**CEDAR STREET & OAK STREET STORM DRAIN  
AND SURFACE IMPROVEMENTS**

**ADDENDUM NO. 1**

July 27 2014

Cedar St & Oak St - unofficial D size

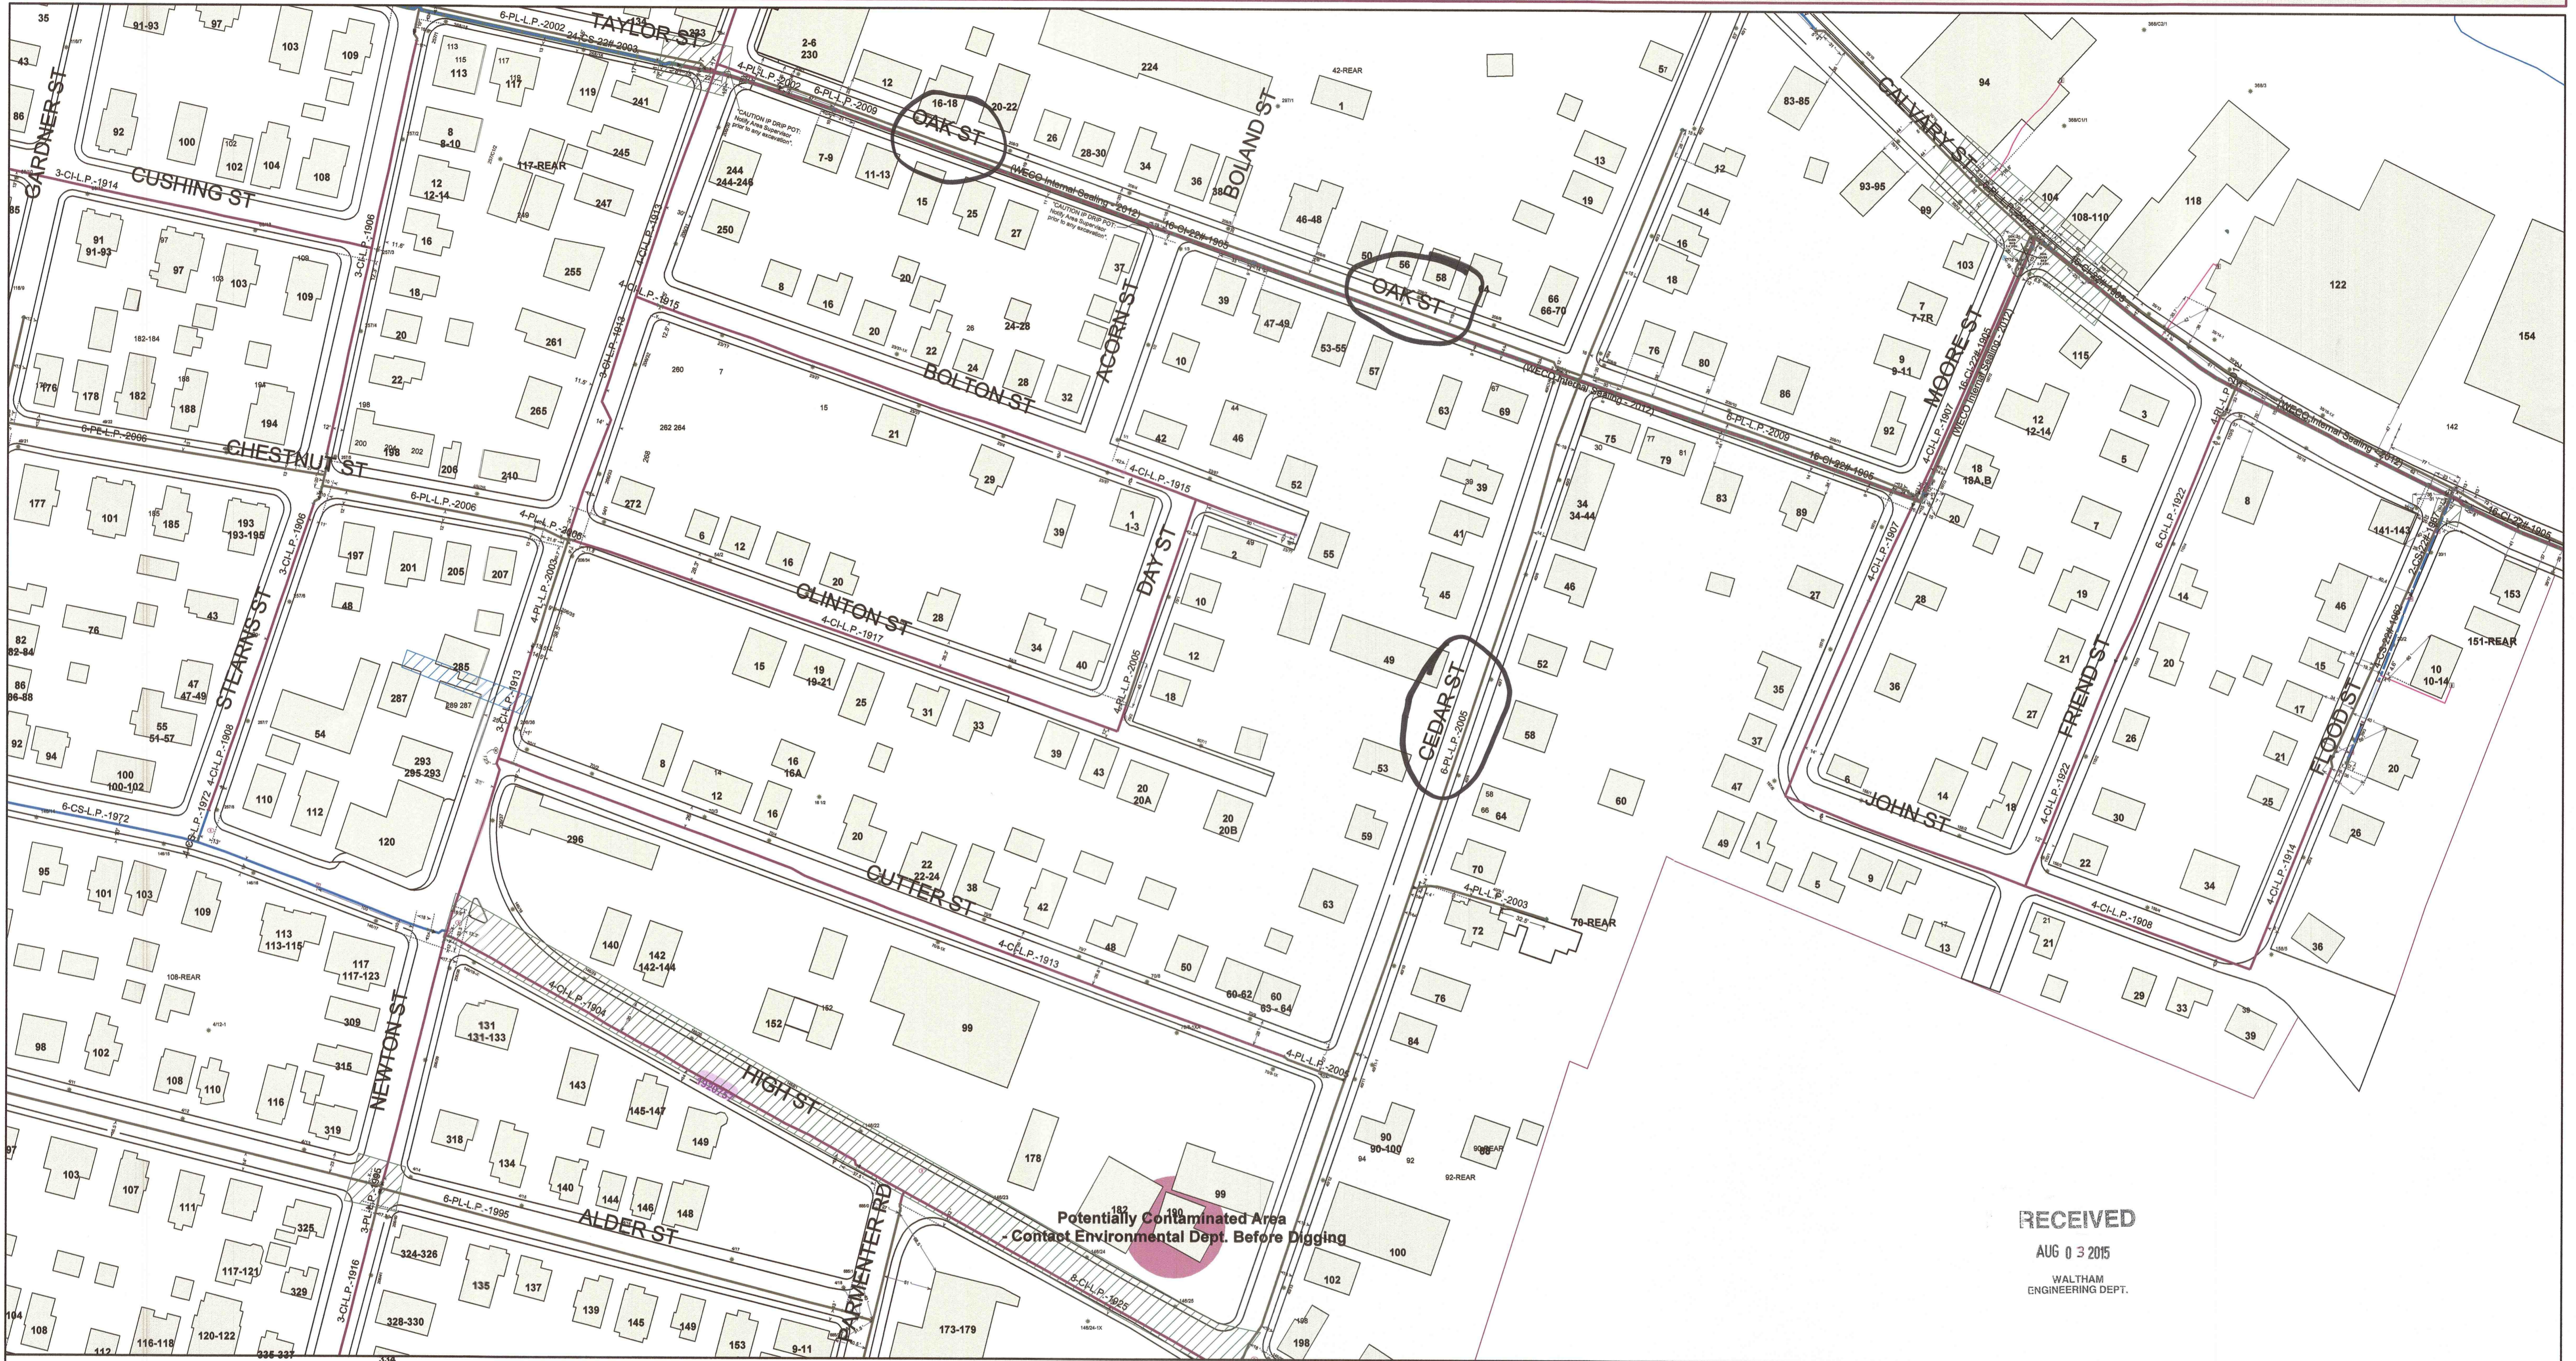
3. At pre bid question on the gas mains, what is live and what is abandoned?

**Answer:** National Grid provided the attached map. Further questions; call National Grid 617-719-2248, Richard Alexander
